## 5.4. L2 OASIS DRIVE WONGA BEACH RECONFIGURATION OF LOT (1 INTO 7)

<b>REPORT AUTHOR(S)</b>	Jenny Elphinstone, Senior Planning Officer
<b>GENERAL MANAGER</b>	Nick Wellwood, General Manager Operations
<b>DEPARTMENT</b>	Development Assessment and Coordination
<b>PROPOSAL</b>	Reconfiguring a Lot (1 lot into 7 lots and drainage reserve)
<b>APPLICANT</b>	Port Pacific Estates Pty Limited c/- Flanagan Consulting Group PO Box 5820 CAIRNS QLD 4870
<b>LOCATION OF SITE</b>	2L Oasis Drive Wonga Beach
<b>PROPERTY</b>	Lot 2 on SP259953
<b>LOCALITY PLAN</b>

Port Pacific Estates Pty Limited  
Proposed 7 Lot Subdivision  
Wonga Beach  
Lot 2 on SP259953  
Proposal Plan

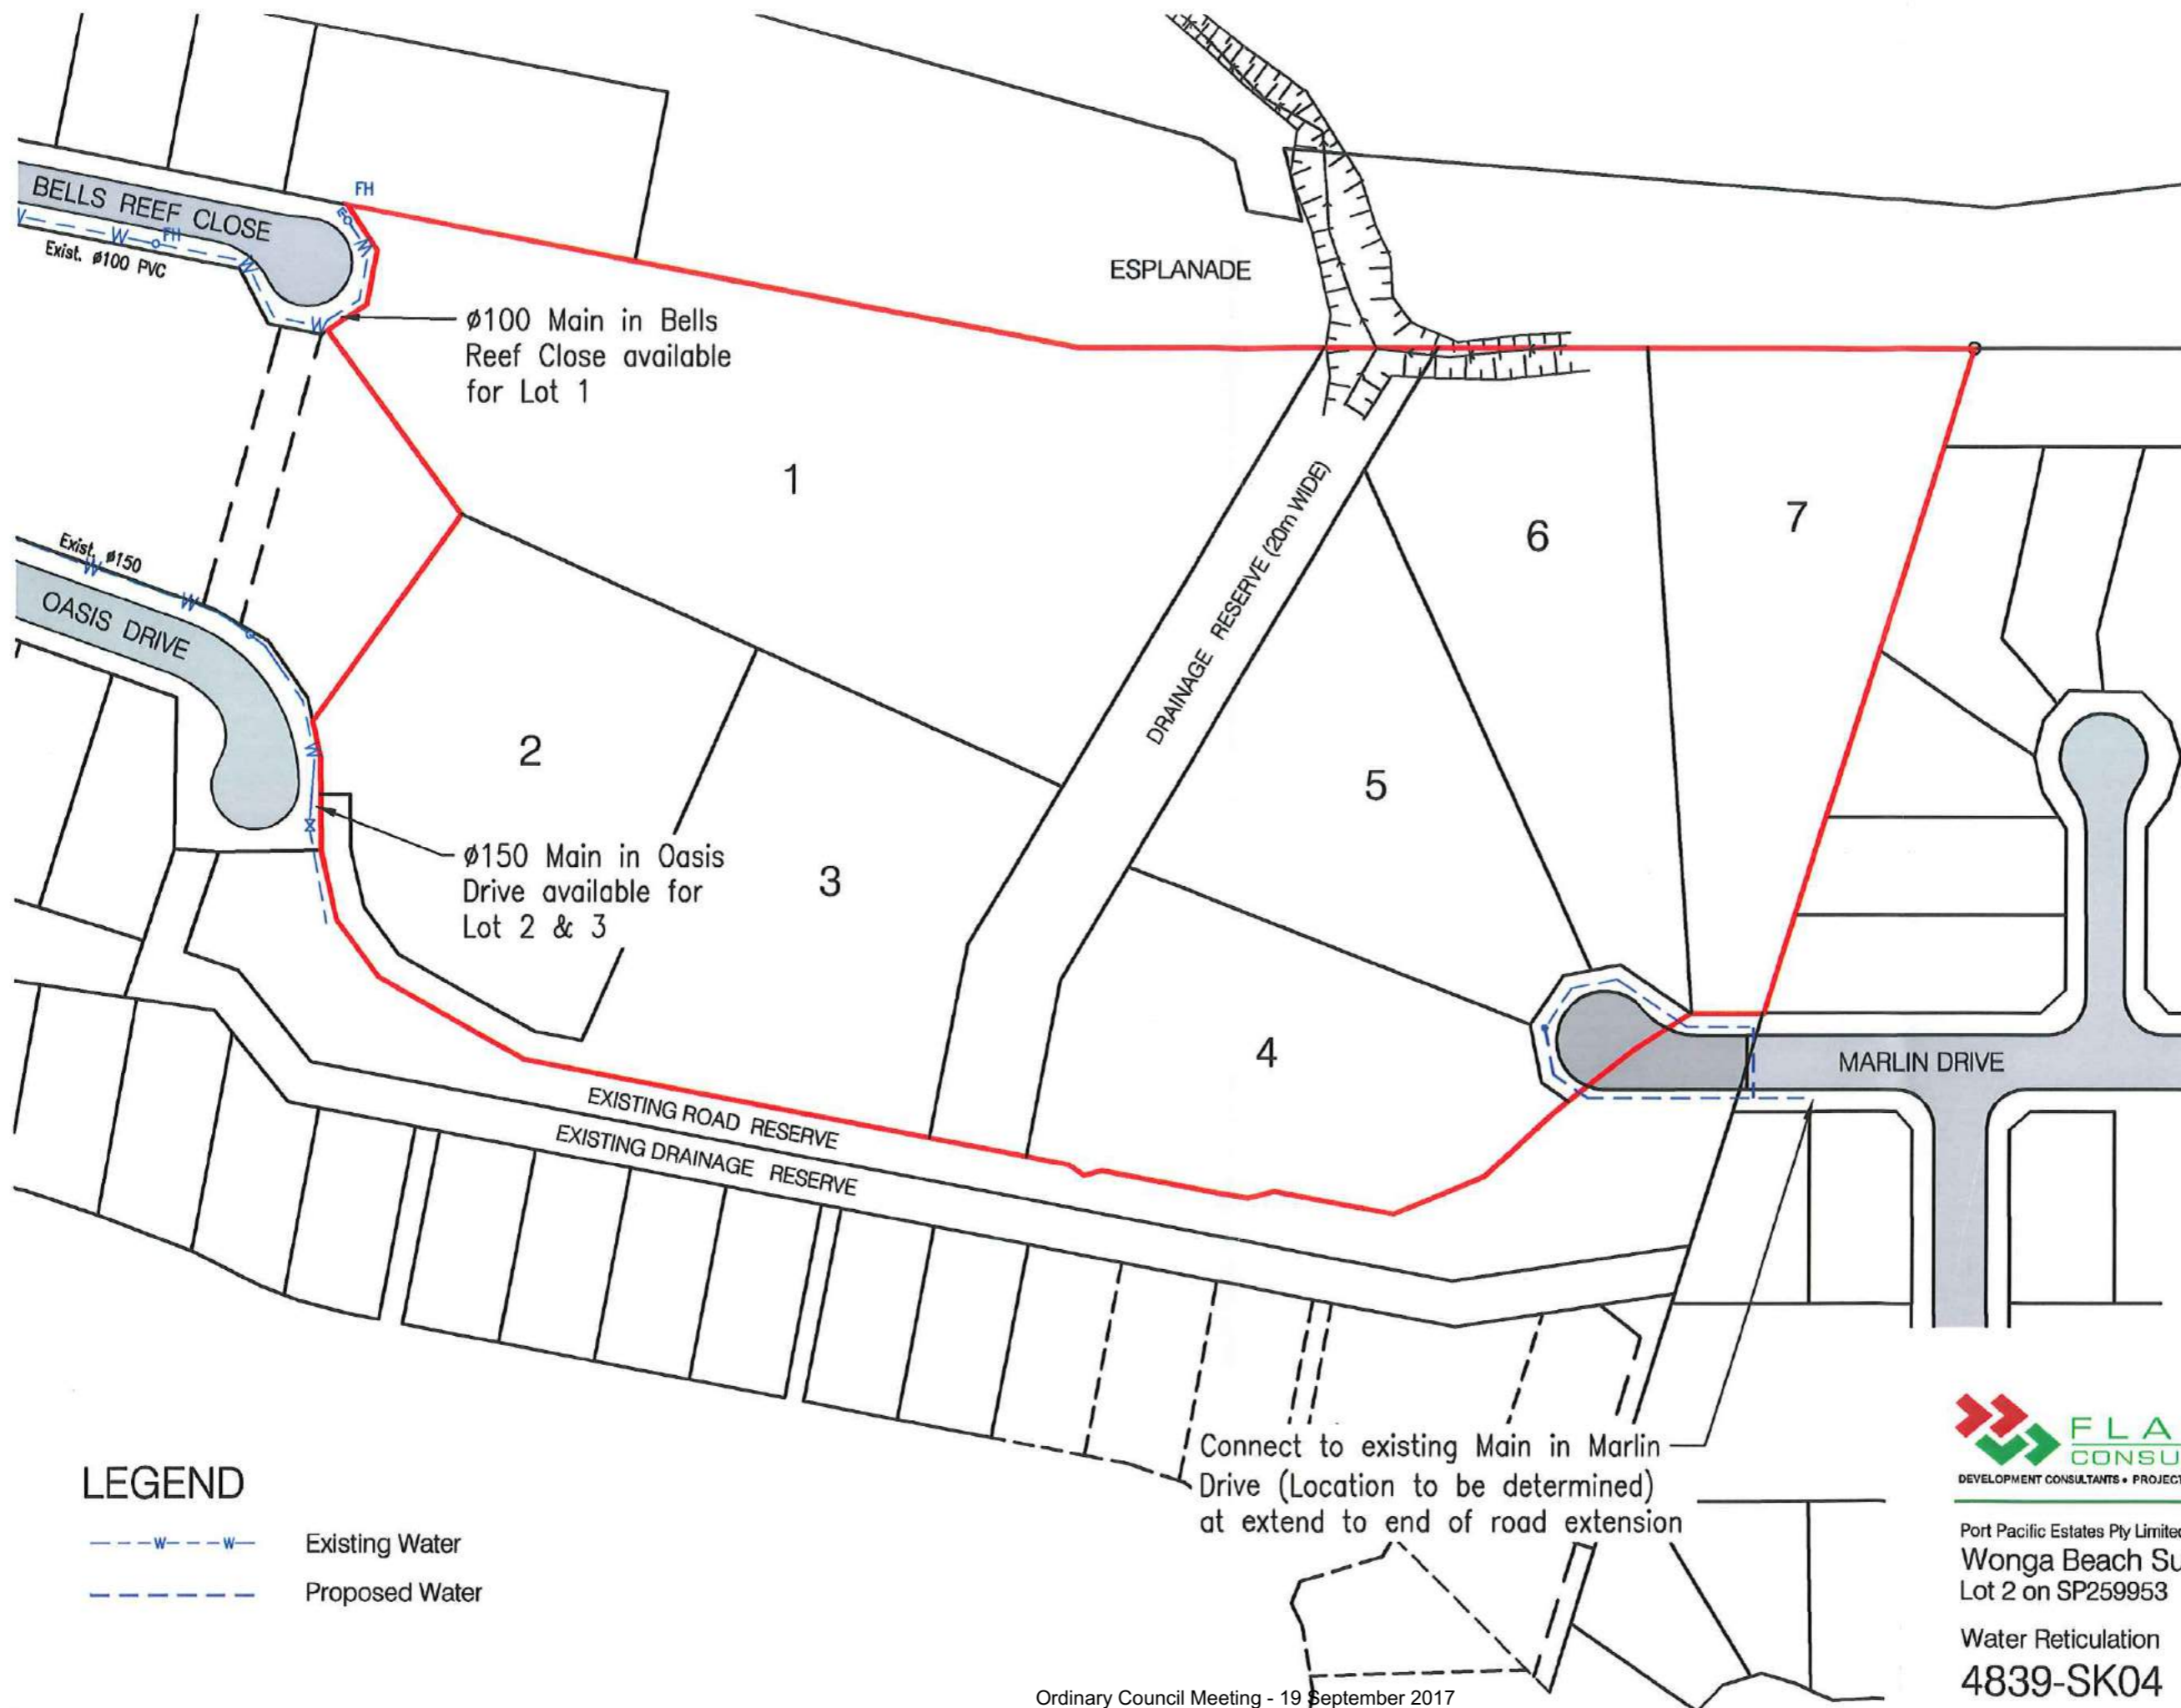
4. The street layout and design is to be generally in accordance with Flanagan Consulting Group Proposal Plan, Sketch 4839-SK01 subject to:
  - a. The south-east corner of Lot 1 is to be truncated to facilitate access from the drainage reserve to the esplanade. The boundary of Lot 1 must be set back 5m from the top of bank for the existing drain based on a detailed survey of the site.

- f. A 6m setback area from the eastern boundary (to the Esplanade) is to be included in a conservation covenant area and is to be vegetated in accordance with Condition 25;

- i. The access strip to proposed Lot 3 must have a minimum width of 4m and a sealed pavement of not less than 3m; and
- j. Any amendments required to comply with the conditions and the requirements of Queensland Streets and the FNQROC Development Manual;

Port Pacific Estates Pty Limited  
Wonga Beach Subdivision  
Lot 2 on SP259953  
Water Reticulation  
4839-SK04

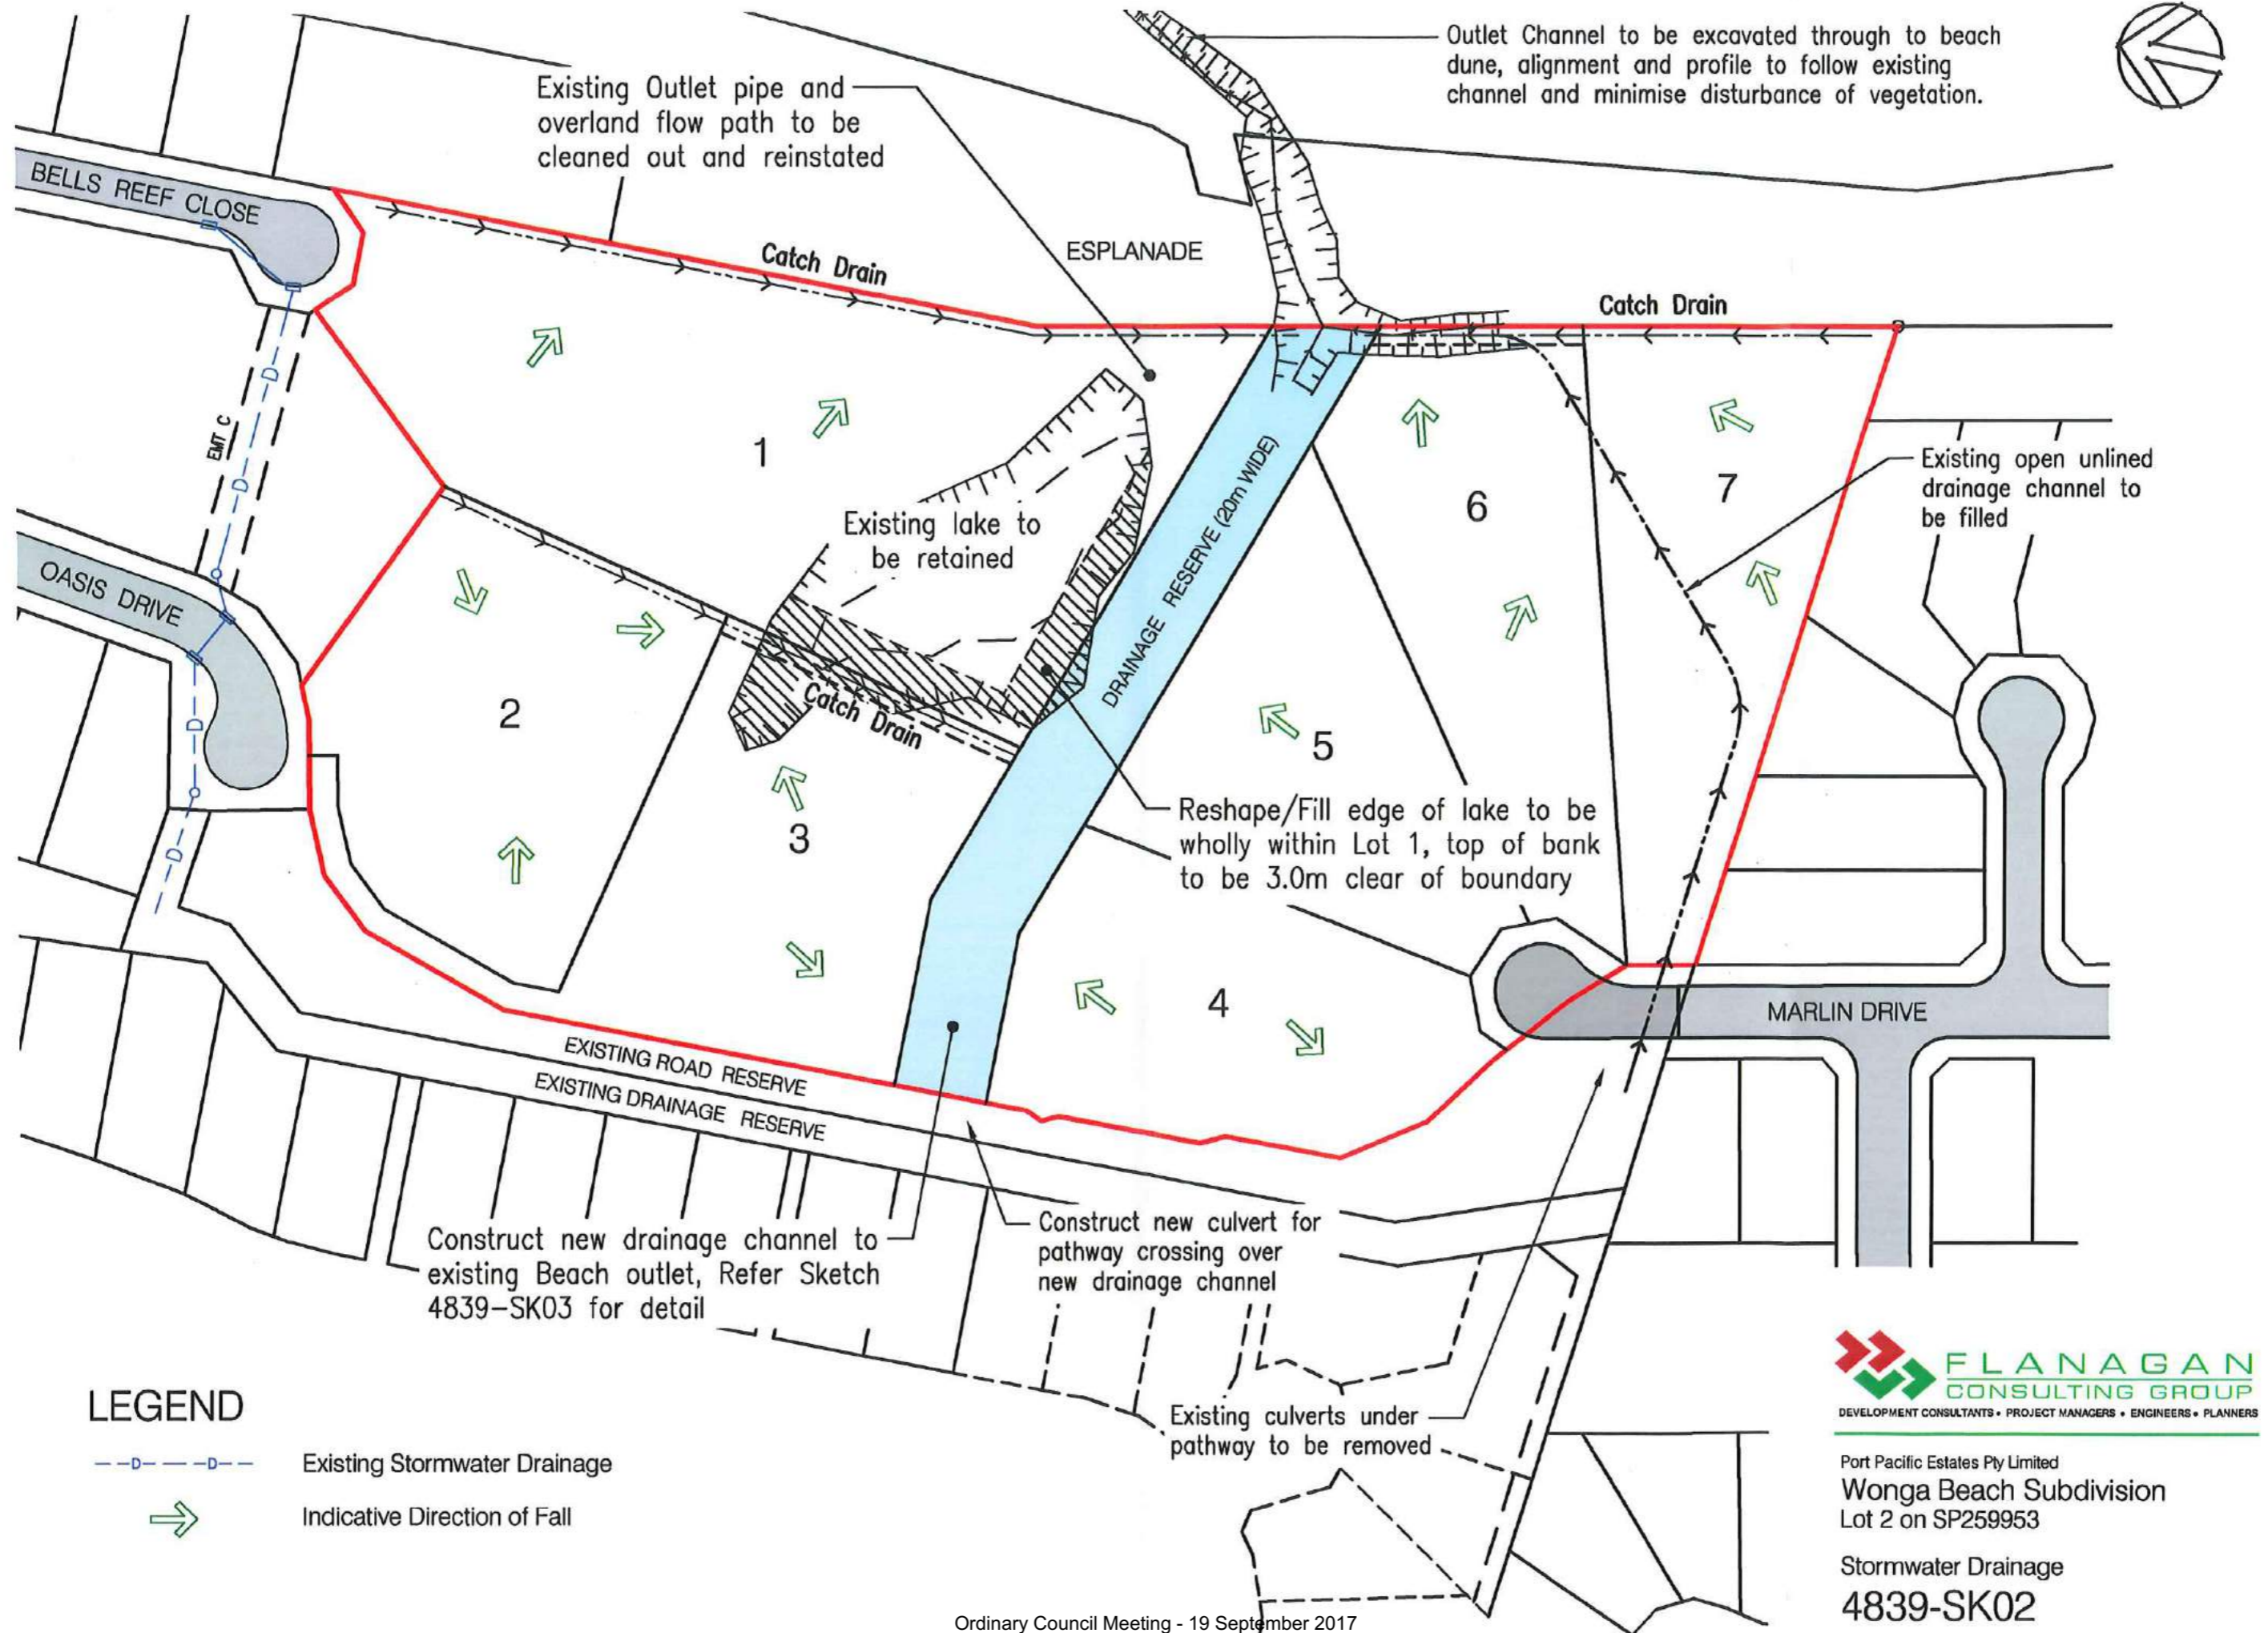
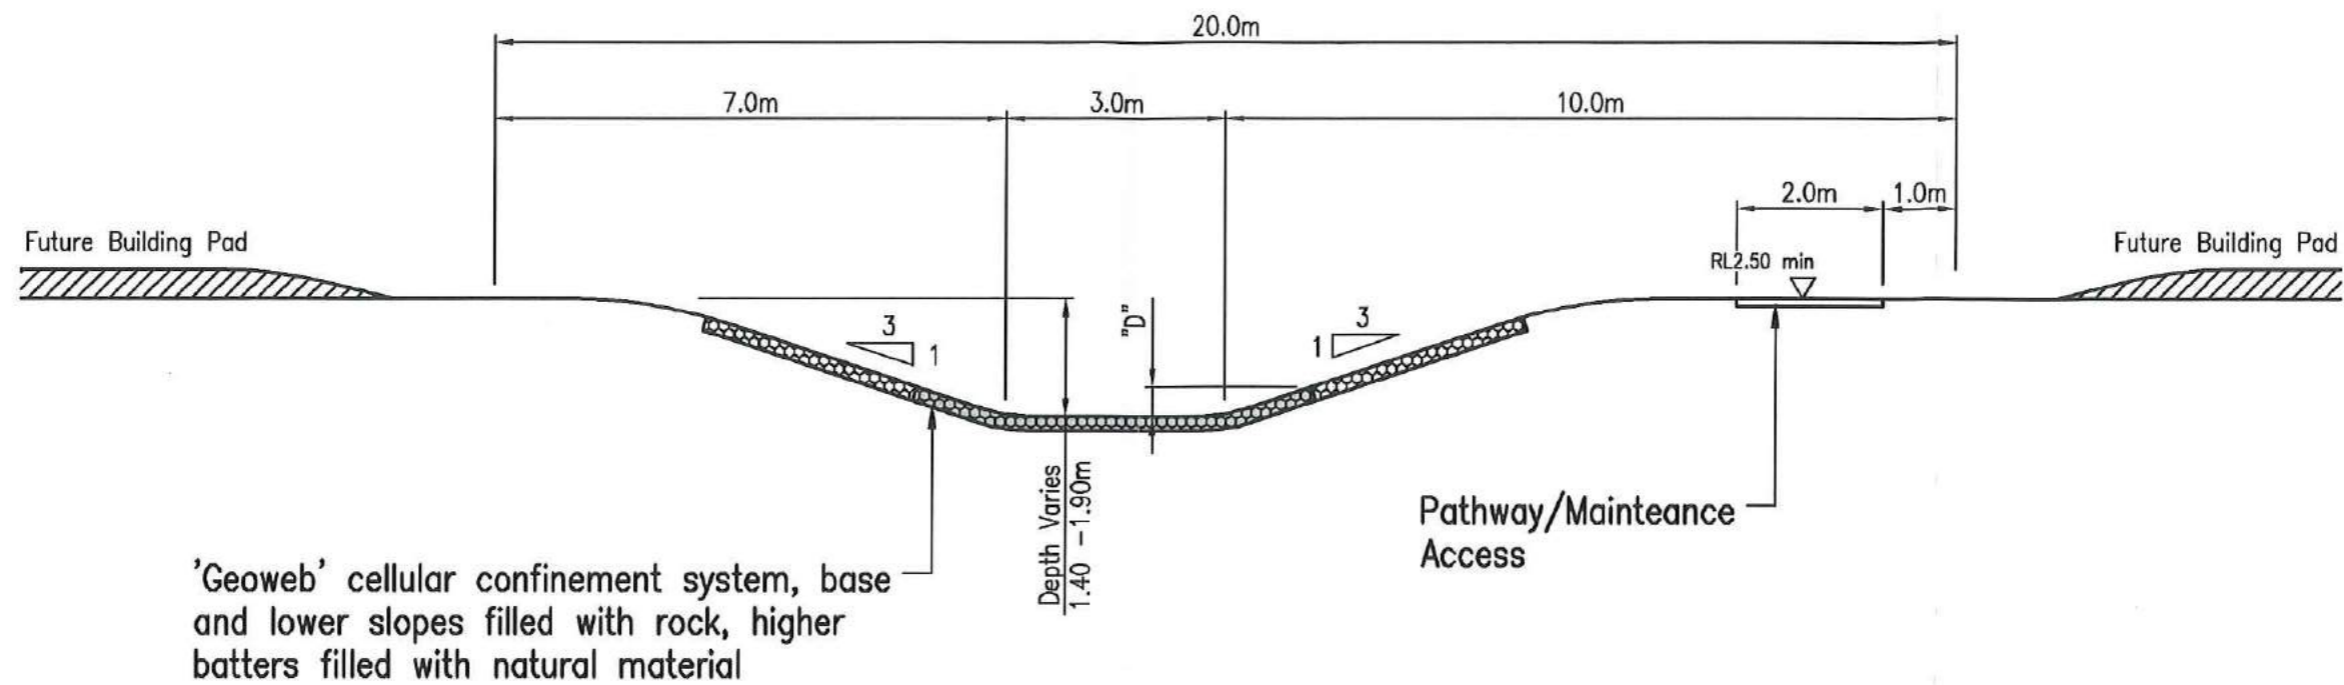
generally in accordance with Flanagan Consulting Group Sketch 4839-SK04 and must be supported by appropriate calculations including hydraulic network analysis demonstrating compliance with FNQROC. In particular, the plan must include:

- a. A minimum 100mm diameter main on one side and a 50mm (63mm OD) main on the opposite side to provide a looped service at the northern end of Marlin Drive;
- b. Provide the conduit for water supply for the full length of the access leg for proposed Lot 3. The conduit does not need to be connected to Council's water supply. The conduit must be capped and staked at the road frontage of the lots and at the end of the access leg for easy identification when a future house is constructed on this lot.
